**SUBDIVISION REVIEW SHEET****CASE NO.:** C8-2020-0112.1A**COMMISSION DATE:** July 25, 2023**SUBDIVISION NAME:** Braker Valley Phase 1**ADDRESS:** 4806 Blue Goose Rd**APPLICANT:** Donald J. Reese (RR Braker Valley, LP)**AGENT:** Chris Rawls (BGE, Inc.)**ZONING:** I-SF-4A (Interim; single-family residence small lot)**AREA:** 68.614 acres**LOTS:** 211**COUNTY:** Travis**DISTRICT:** 1**WATERSHED:** Walnut Creek**JURISDICTION:** Full Purpose

FINAL PLAT  
**BRAKER VALLEY PHASE 1**

CITY OF AUSTIN –DEVELOPMENT SERVICES DEPARTMENT  
SUBDIVISION APPLICATION – MASTER COMMENT REPORT

CASE NUMBER: C8-2020-0112.1A  
UPDATE: U0  
CASE MANAGER: Joey de la Garza Email: [Joey.DelaGarza@austintexas.gov](mailto:Joey.DelaGarza@austintexas.gov)

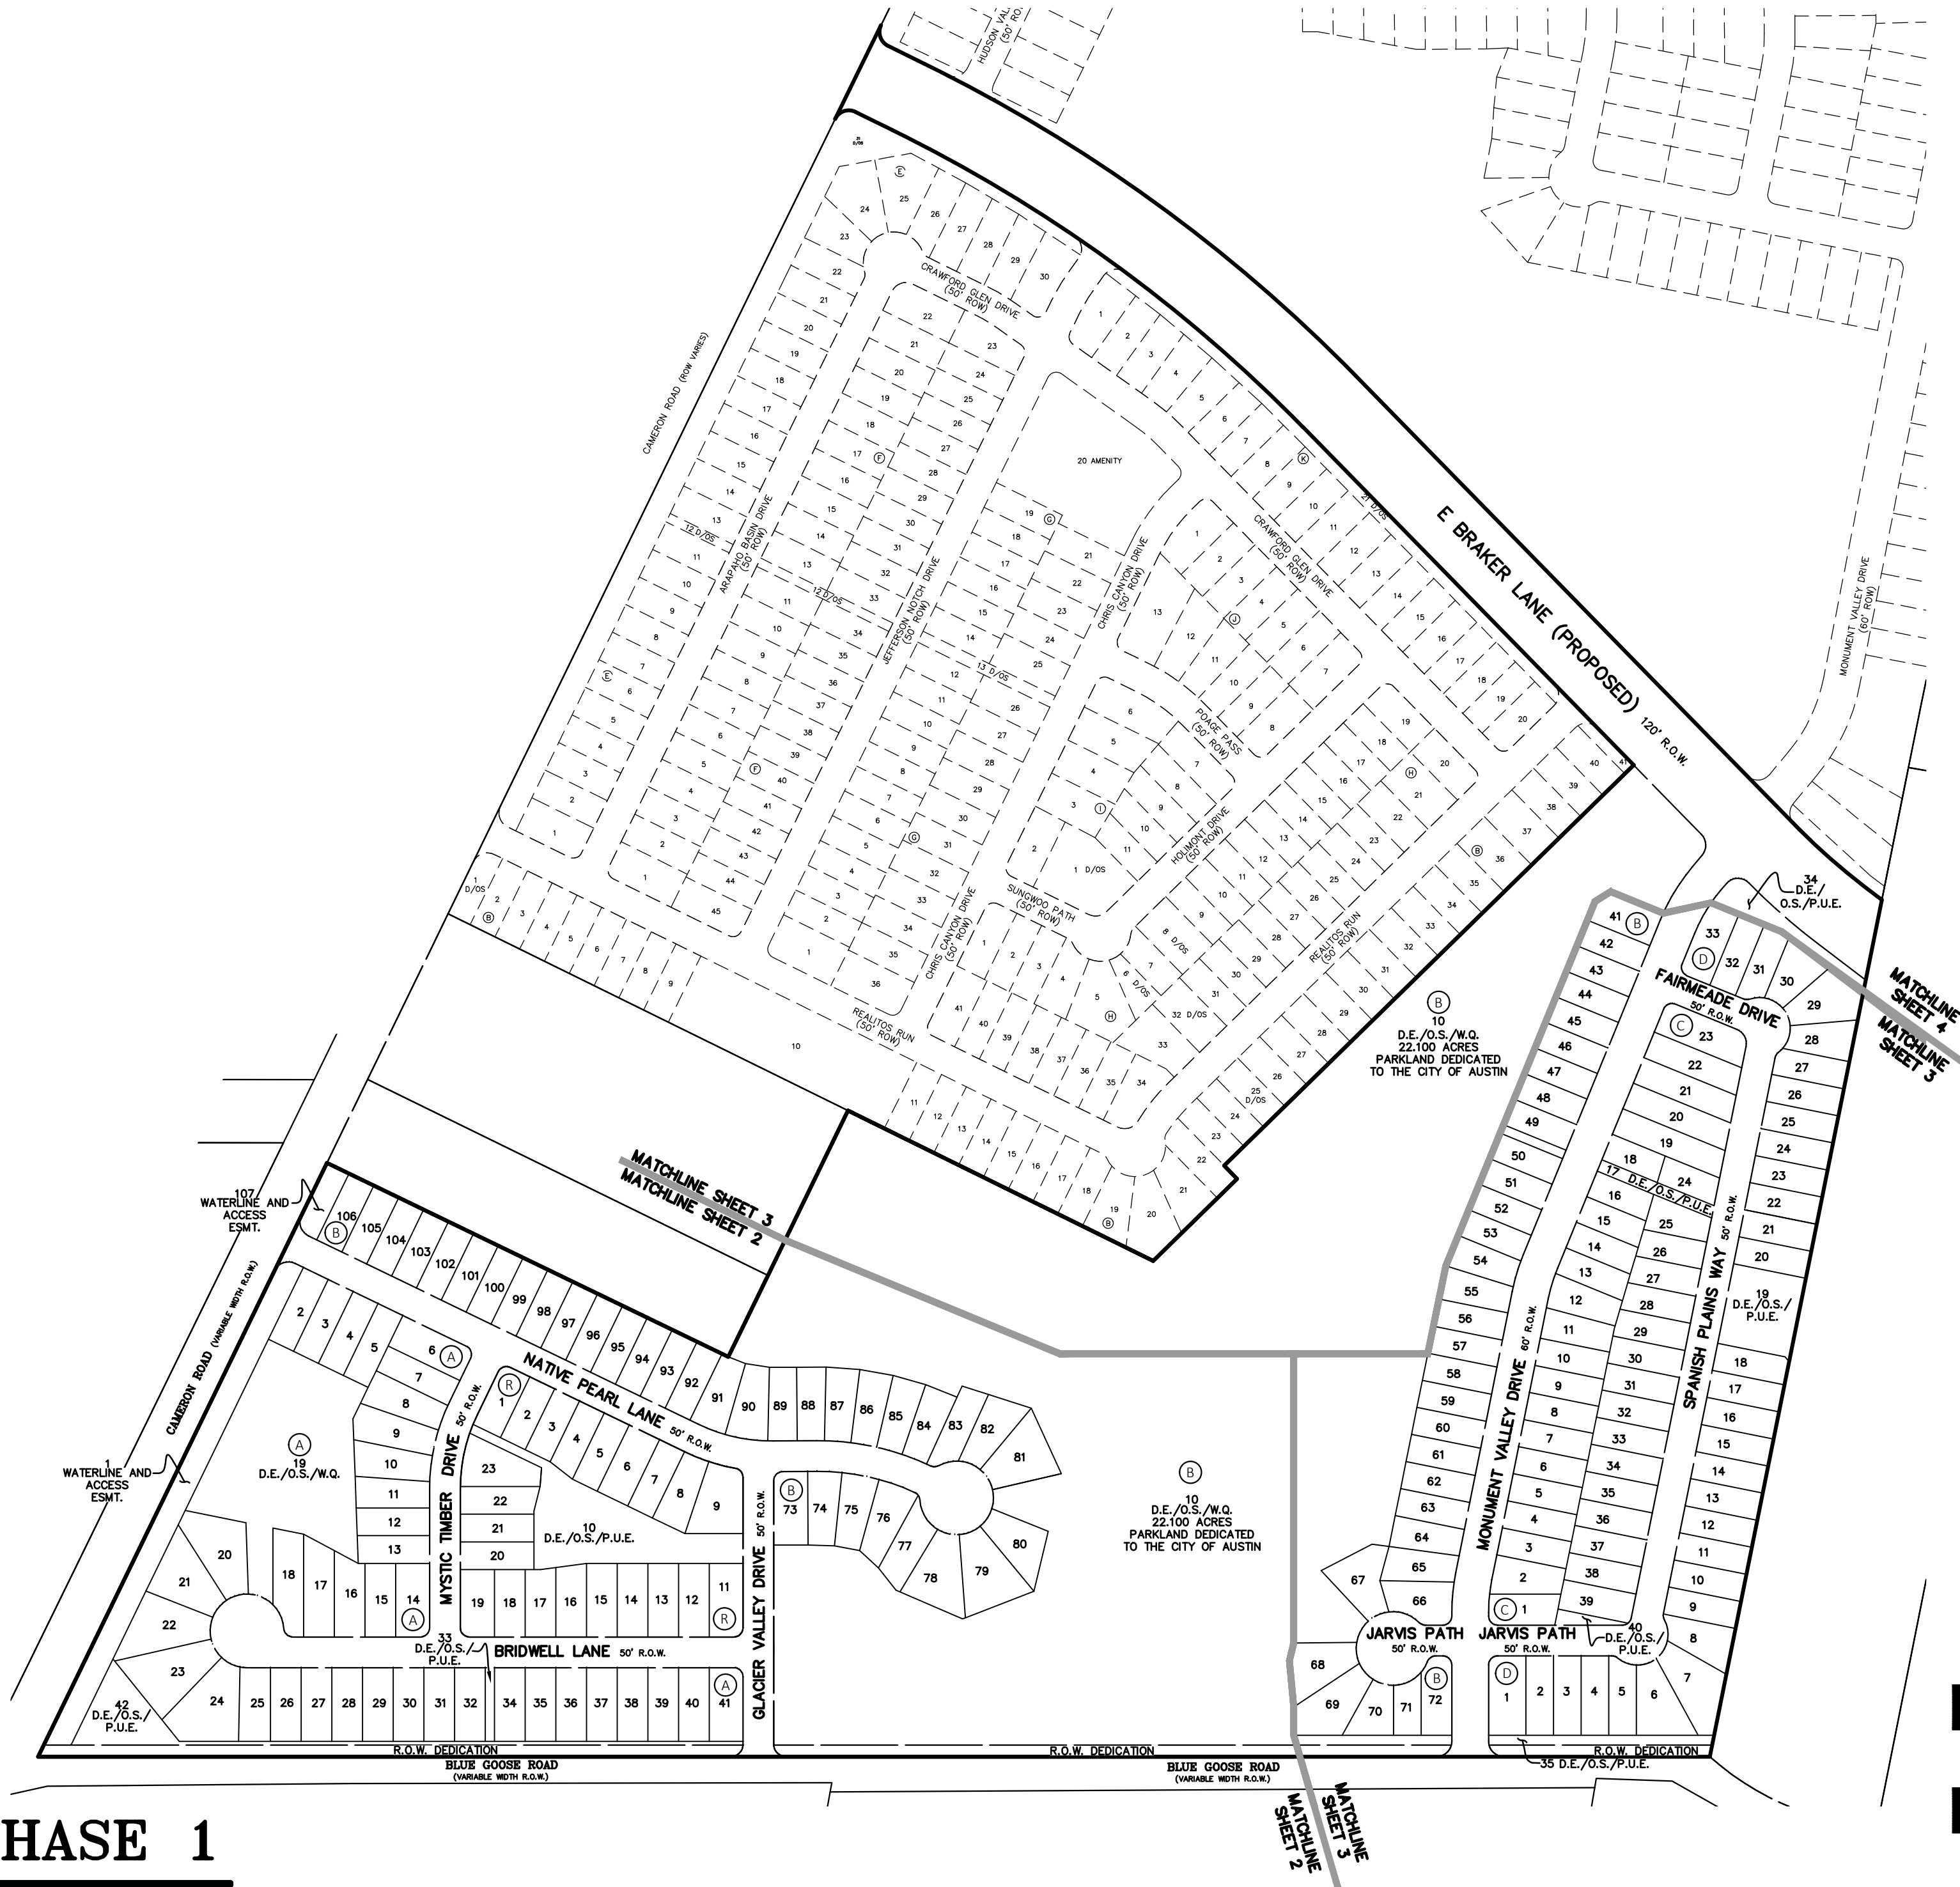
AD2: Please indicate whether **GLACIER VALLEY DR** and **MONUMENT VALLEY DR** are going to continue south of BLUE GOOSE RD

AD3: Please provide the plans showing the extension of E BRAKER LN east of the existing portion

AD4: Street names reserved more than three years in the past are subject to re-review against the Street Name and Labeling Standards currently in effect. So, although **CRAWFORD GLEN DR**, **CHRIS CANYON DR** was reserved for an adjacent project labeled in May of 2012, it is being rejected at this time since the use of the names may compromise or delay emergency response. Please select a different name, re-label and resubmit.

AD5: Please update the label **E US 290 HWY** with the directional E on the vicinity map as seen here

- SR 2. Add Case #C8-2020-0112.1A in the bottom right hand corner of each sheet. 25-1-83 or 30-1-113
- SR 3. Amend the following note on sheet 7, which is required to be placed on the plat by the Travis County Clerk's office: 25-1-83; 30-1-113: "This subdivision plat is located within the Full Purpose jurisdiction of the City of Austin on this the \_\_\_\_\_ day of \_\_\_\_\_ 20\_\_."

- SR 4. Add a sheet to the plat that contains the size of each lot in square footage along with the percentage of proposed small lots. 25-1-83
- SR 5. Add the term "A Small Lot Subdivision" under the name of the proposed subdivision on each sheet of the plat. 25-1-83

- SR 7. Please amend the administrative City of Austin approval block on sheet 7 to the following: 25-1-83, 30-1-113  
APPROVED, ACCEPTED AND AUTHORIZED FOR RECORD BY THE DIRECTOR,  
DEVELOPMENT SERVICES DEPARTMENT, CITY OF AUSTIN, COUNTY OF TRAVIS, THIS  
THE \_\_\_\_ DAY OF \_\_\_\_\_, 20\_\_, AD.

- SR 8. Replace the notary signature block on sheet 7 as follows: 25-1-83 or 30-1-113  
State of Texas §  
County of \_\_\_\_\_ §

- SR 11. Amend plat note 46 to the following: "If a transmission easement is on a property subject to a future site plan or construction, all construction activity or grading within the easement must be coordinated with Austin Energy prior to commencement." 25-1-83

- SR 12. Revise the Land Use Commission approval block on sheet 7 as follows 25-1-83 (or 30-1-113):  
Accepted and authorized for record by the Land Use Commission of the City of Austin, Texas, on this, the \_\_\_\_\_ day of \_\_\_\_\_ 20\_\_.

SR 13. Add/modify the Travis County Clerk recordation block as shown: 25-1-83, 30-1-113  
STATE OF TEXAS §  
COUNTY OF TRAVIS §

Remove note 48. There are no City of Austin water and wastewater easements within the boundaries of the plat. The only existing waterline easement within the boundaries of the plat belongs to the City of Pflugerville, and City of Austin notes are not applicable.
